SAVANNAH BOARD OF ZONING APPEALS

STAFF REPORT

MPC FILE NO.	26-003712-ZBA
MPC STAFF	Ashley Catterton
DATE	October 22, 2026
PETITIONER	Irvin Riley Jr. on behalf of A & I Legacy Group LLC
ADDRESS	1221 Richards Street
PARCEL ID	20019 04002
ALDERMAN DISTRICT	1 – Bernetta Lanier
CHATHAM COUNTY COMMISSION DISTRICT	8 – Marsha Buford

Proposed ADU Elevations for 1221 Richards Street

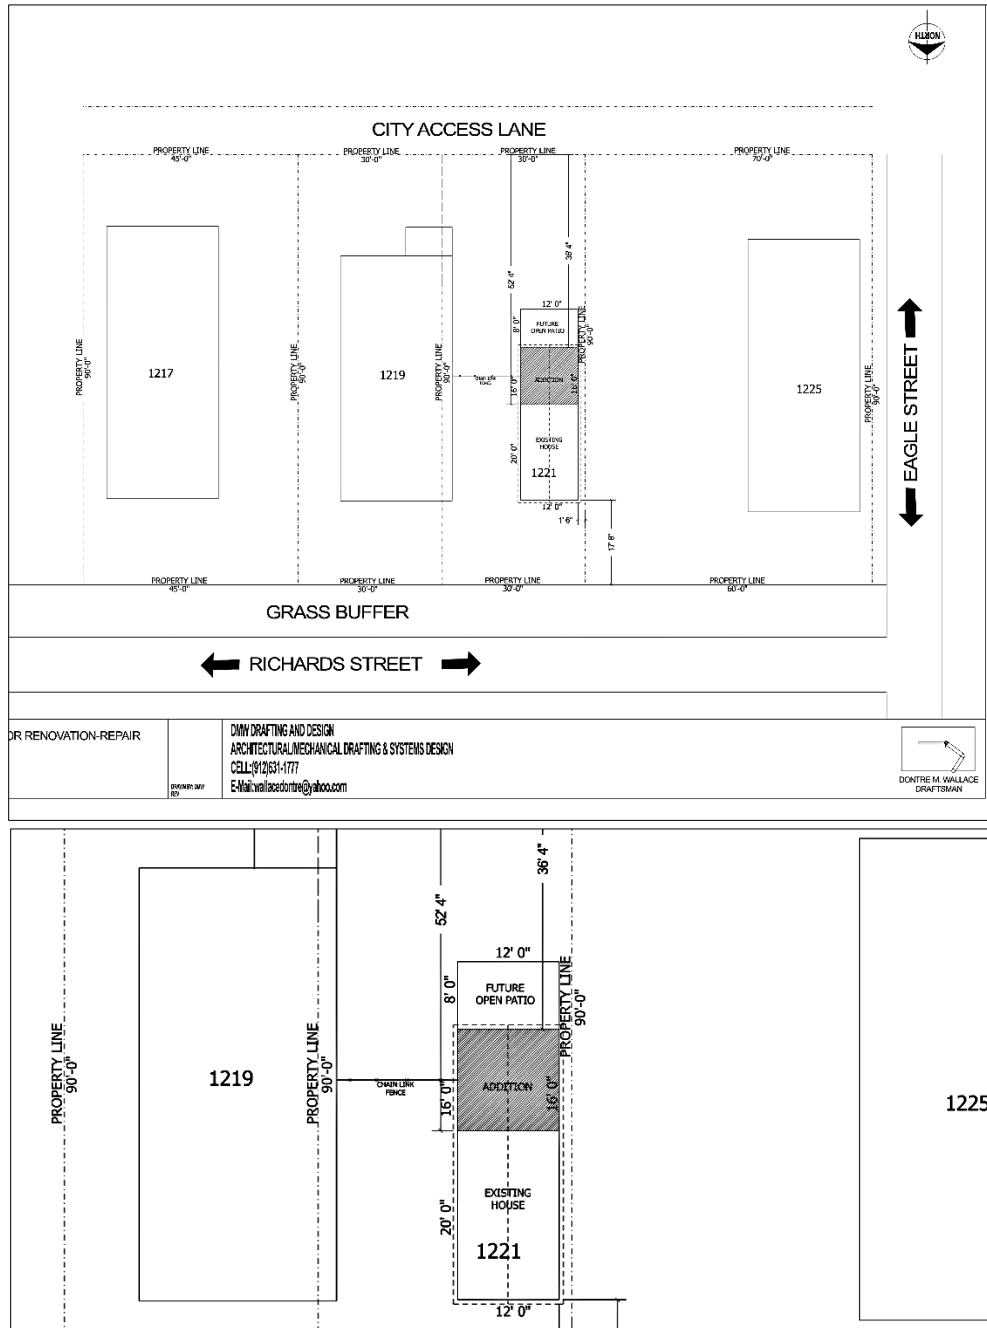
- The submitted site plan identifies a future open patio associated with the proposed ADU. Any subsequent improvements or modifications shall be subject to applicable zoning and permitting requirements.

Staff Comment: *The subject property contains an existing 240-square-foot ADU proposed for rehabilitation and expansion. Based on the submitted conceptual site plan, the proposed addition generally maintains the existing structure's alignment along the side property line. Although this existing configuration presents challenges in meeting the required five-foot side-yard setback, the Petitioner has not demonstrated that strict application of the setback requirements would deprive the property of rights commonly enjoyed by other properties within the RSF-5 zoning district or result in unnecessary and undue hardship. Furthermore, it has not been established that the proposed improvements could not be accommodated through an alternative design that complies with the applicable setback requirements.*

1. **Setback Clarification:** Provide a revised site plan confirming the existing and proposed side-yard setbacks for the ADU structure and roof eave. The submitted plans identify a structural setback of approximately one (1) foot, six (6) inches, which does not align with the requested two-foot setback reduction. Any revisions to the variance requests shall be reviewed to determine whether additional public notice or other procedural requirements apply.

3. **Revised Plans:** Submit a revised site plan accurately identifying the existing structure, proposed addition, and associated improvements, including the future open patio. Any future enclosure, expansion, or modification shall be subject to applicable zoning and permitting requirements.
